**BULGA OPTIMISATION
PROJECT MODIFICATION 3
AND BULGA UNDERGROUND
MODIFICATION 7**

Submissions Report

December 2019

Figure 6 Predicted annual average dust deposition levels due to the BCC

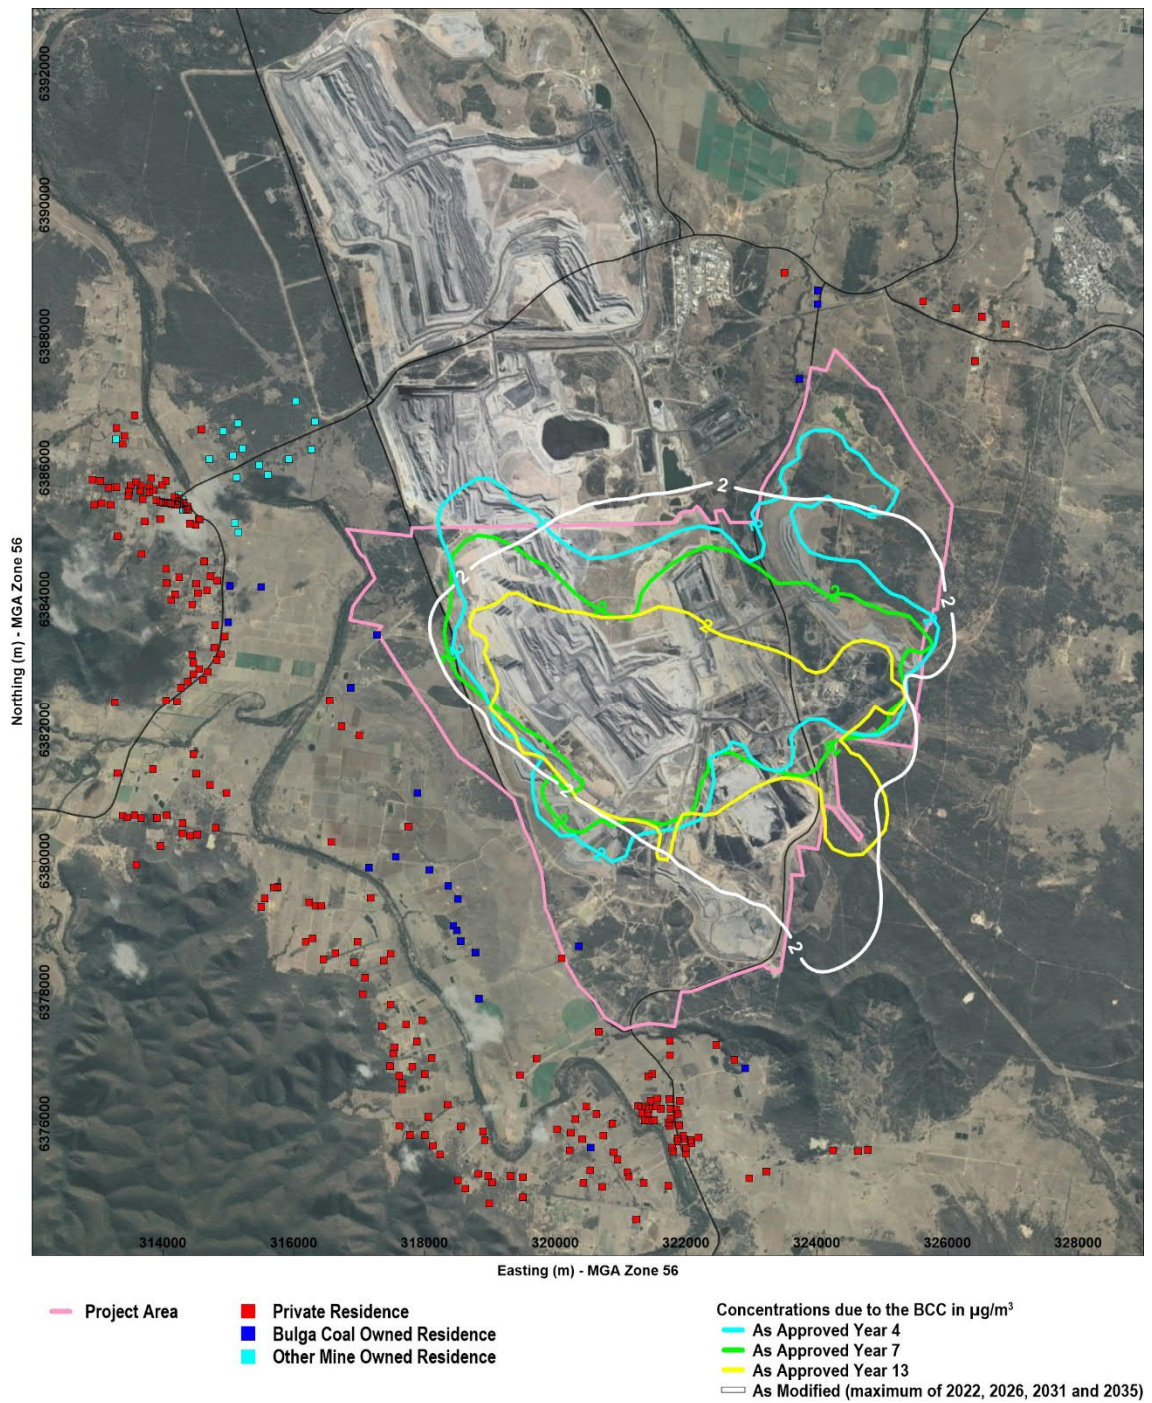
The Proponent must provide an assessment of particulate emissions from the existing approved operations at the Bulga Coal Mine and evaluate changes to air quality resulting from SSD 4960 Mod 3. This assessment is needed because the modification will result in new activities to the south of the existing project area. Incremental dispersion contour plots must be included.

The Air Quality Impact Assessment (AQIA) does not present a complete assessment of the air quality impacts from the current approved operations. Rather assumes SSD 4960 Mod 3 will not change air quality impacts. Predicted impacts above the assessment criteria are to occur to the north-east and north-west of the Bulga Coal Mine, towards Bulga. However, no particulate impacts above the EPA's assessment criteria are predicted to the south of the Bulga Coal Mine towards Broke. It is unclear how these impacts compare to the existing approved operations of Bulga Coal Mine.

Contour plots have been prepared to provide a comparison of the Proposed Modification to the Approved Development, in terms of the contribution of the BCC to local air quality. These plots are shown in **Figure 1** to **Figure 6** and include:

The comparisons in **Figure 1** to **Figure 6** show that the key contours representing the contribution of the Proposed Modification (i.e. BCC with SSD-4960 Mod 3) to local air quality are largely within those of the Approved Development in terms of maximum extent. Some deviations are evident, for example, annual averages show a change in contribution to the south due to proposed area mining in this area, and some of these differences are also explained by the factors outlined above.

Figure 7 predicted maximum 24-hour average PM₁₀ concentrations due to all sources

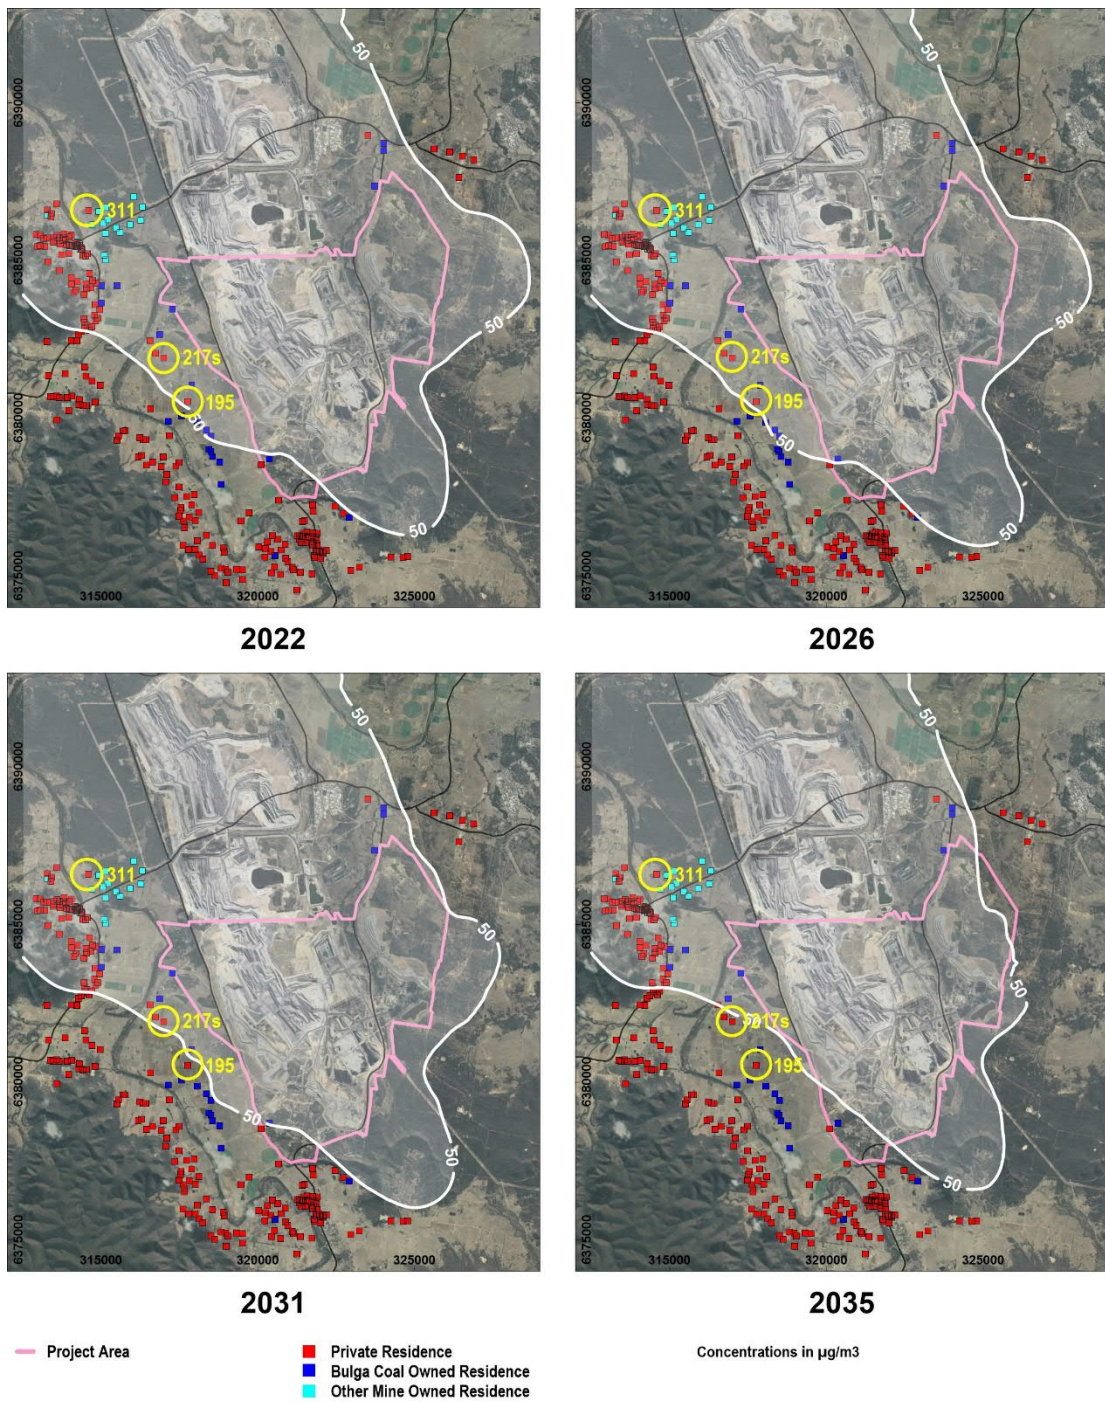
The Proponent must provide justification for the use of Properties 195, 217s and 311 for assessing the 24-hour PM₁₀ impact assessment criteria as well as identifying all properties predicted to experience additional exceedance days as a result of SSD 4960 Mod 3.

The AQIA predicts for the cumulative scenario that numerous private residences will exceed the 24-hour average PM₁₀ criteria of 50 µg/m³ over all years modelled (Figure 19 and Appendix D). The AQIA examines the potential contribution of each source to cumulative concentrations at three locations. Specifically, Property 195 is predicted to experience two exceedance days with a significant project only contribution of 24 µg/m³. Property 311 is also predicted to experience two exceedance days (9 µg/m³) and Property 217s is predicted to experience one exceedance day (6 µg/m³).

Figure 19 of the AQIA showed that maximum 24-hour average PM₁₀ concentrations may exceed the EPA's 50 µg/m³ criterion at various private properties, due to contributions from the BCC (as modified), Mt Thorley Warkworth mine and background (other) sources of particulate matter. Three of the closest properties within the extent of predicted impact, in various directions from the BCC, were selected for further, contemporaneous data analysis. Representative properties meeting this criteria were identified as 195, 217s and 311 and their locations are shown in **Figure 7**, also showing predicted maximum 24-hour average PM₁₀ concentrations due to all sources. All properties predicted to experience additional exceedance days as a result of SSD 4960 Mod 3 can be identified from Appendix D of the AQIA.

There is no known guidance or standard for defining what constitutes a significant project only contribution. The AQIA has used historical monitoring data to identify existing conditions and used dispersion modelling to forecast the potential future conditions. This process led to the following conclusions:

- *“Maximum 24-hour average PM₁₀ concentrations may continue to exceed the EPA's 50 µg/m³ criterion at various locations in the vicinity of the Bulga Coal Complex (including private properties), due to contributions from the Bulga Coal Complex (as modified), Mt Thorley Warkworth mine and background (other) sources of particulate matter. Specifically, the model predictions indicated that there may be up to two days each year when the Bulga Coal Complex (as modified) would contribute to an exceedance of 50 µg/m³ at the nearest locations to the west of the Bulga Coal Complex. These predictions did not highlight any significant change in air quality as they were within the range of historical measured conditions. It is concluded that 24-hour average PM₁₀ concentrations will continue to be variable from day-to-day, due to existing conditions and sources, and that operations will need to be managed in a way which minimises the contribution to off-site PM₁₀ levels, as is done under the existing approved operation.”*
